PLANNING
COMMISSION
EXHIBIT #60

✓XC:PC 11/17
PLANNING
COMMISSION
EXHIBIT #61

Subject: "The Preserve" Preliminary Open Space Subdivision & Open Space Plan
Ingham Hill and Bokum Roads (Maps 55, 56 & 61, Lots 6, 3, 15, 17 & 18)
Residence Conservation C District, Aquifer Protection Area
Applicant: River Sound Development LLC, Agent: Robert A. Landino, P.E.

**PLANNING
COMMISSION
EXHIBIT #61a.**

OPEN SPACE SUBDIVISION - PRESERVATION PLAN

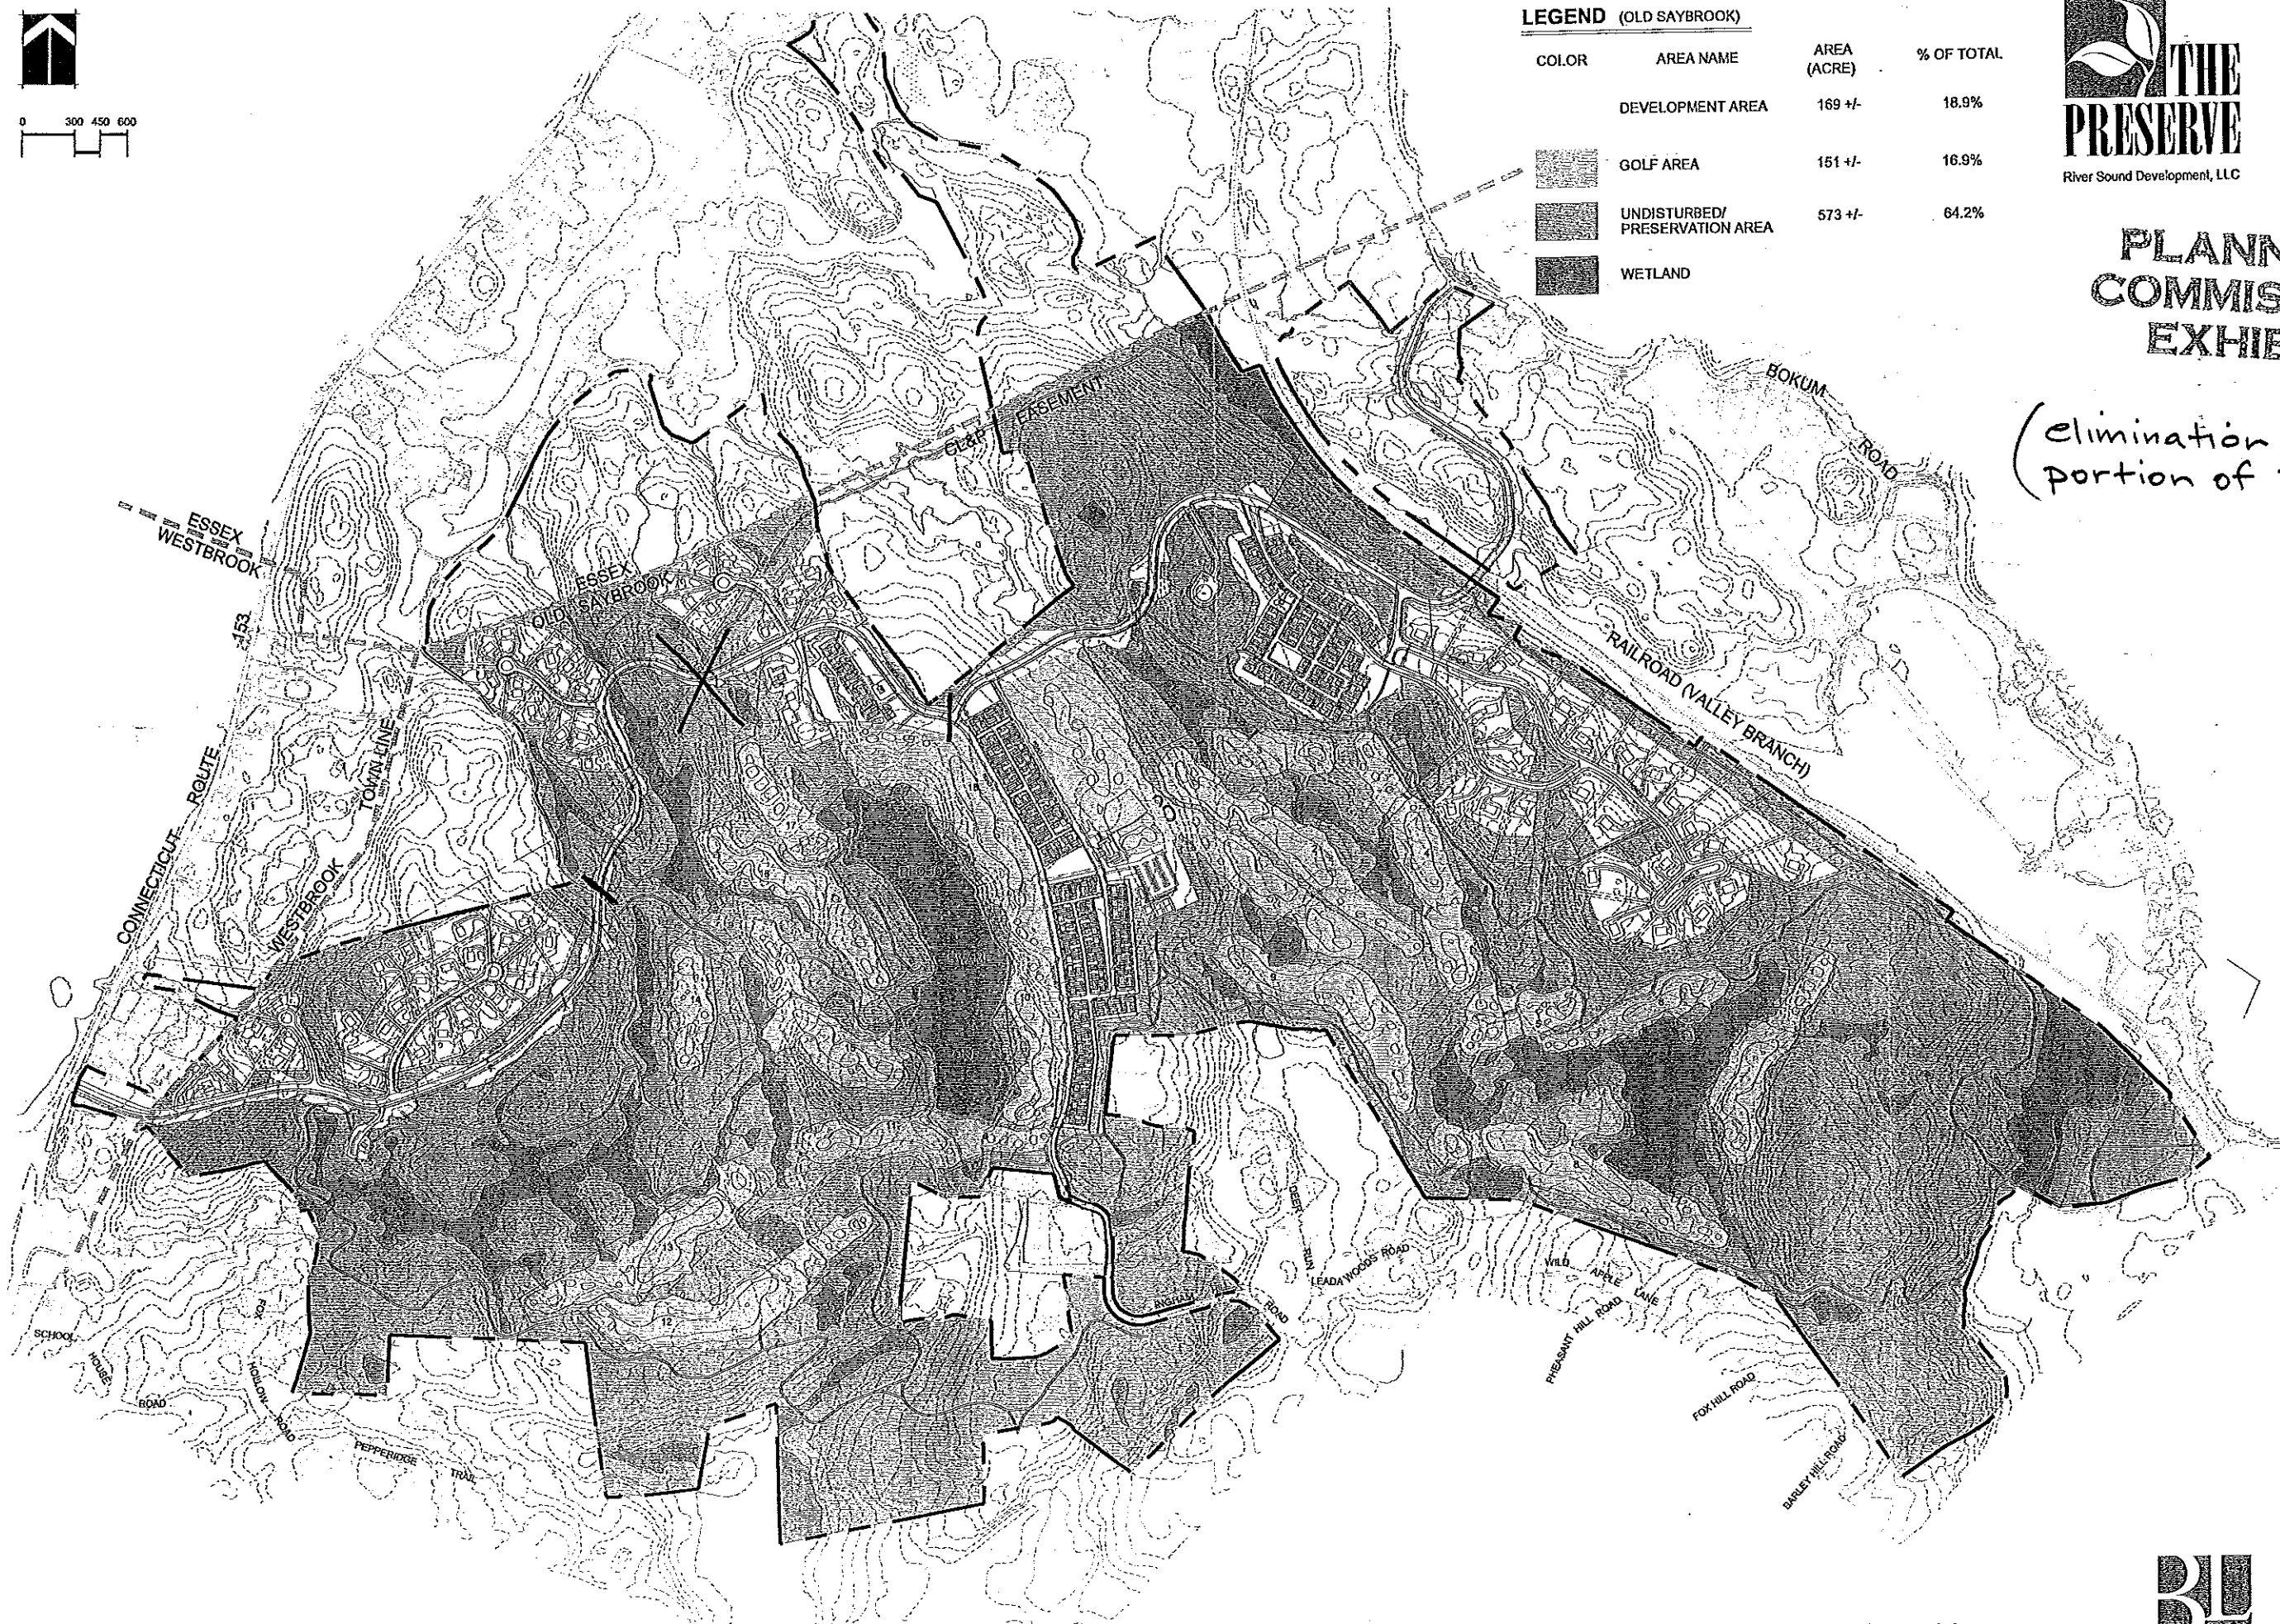
The ^{west}east side of the proposed development contains a large portion of the most sensitive wetlands on the property, including a significant part of the headwater streams of the Oyster River. The elimination of the large infrastructure in this area would provide a great environmental plus. This could be accomplished by eliminating the portion of Road A between Road C and Road H, and then connecting Road H through the Village area to Ingham Hill Road. In addition, if the piece of Road A just west of the proposed fire house were routed around the wetland on the north side, these road changes would eliminate all wetland crossings and the accompanying bridge structures.

*(elimination of a
portion of Road A)*
